C L E P A
*European Association of
Automotive Suppliers*

CLEPA analysis of belt contact width measurement (ref. GRSP/2018/6)

63rd GRSP session, 14-18 May 2018
Palais des Nations, Geneva

*Examples how to measure certain cases:
(Cross section of the belt)*

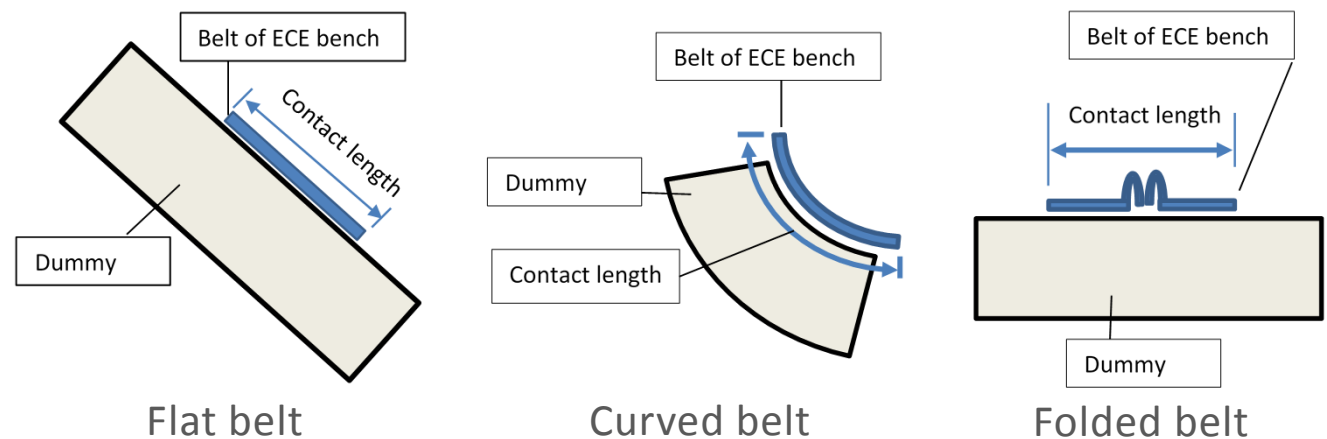
- Definition of measurement spots is subjective
- Procedure needs to be improved with regards to feasibility and consistency
- Measurement seem to add no value in assessing child seats as all tested CRS achieve similar values

Belt width @ simulated buckle

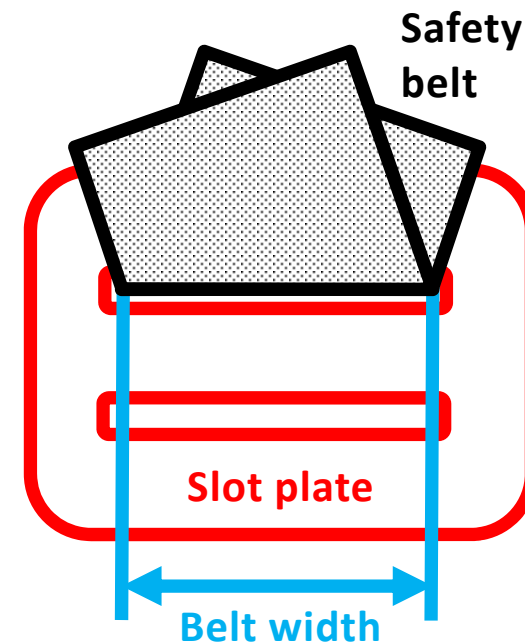
Observation:

- Lap belt contact width shows clear difference between two types of booster seat designs.
- The slot plate provides a suitable reference for measurement and allows good accessibility.

Proposal:

To assess the contact width of the lap belt it is proposed to measure the belt width at the slot plate of the simulated buckle.

Figure 1 - Suggested measurement

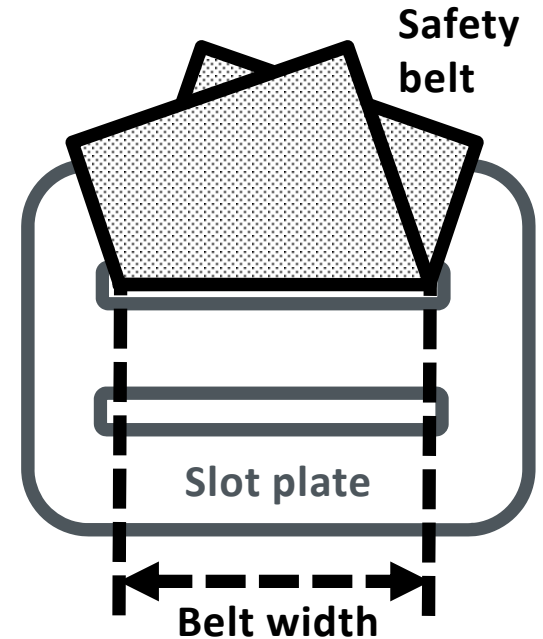
Proposal to amend 6.2.12.:

In the case of ~~non-integral child restraint systems~~ booster seats and booster cushions, the ease with which the straps and tongue of an adult belt pass through the fixture points shall be examined.

The simulated buckle, when installed on the bench, prior to all dynamic tests, shall not:

- (a) pass through the fixture points or belt guides of non-integral child restraint systems, or
- ~~(b) permit a lie of the belt that leads to any contact narrower than 38 mm between the adult belt or simulated buckle and the child,~~
- (b) permit a lie of the lap belt within the slot plate that has a width narrower than 38 mm as described in Figure 1**
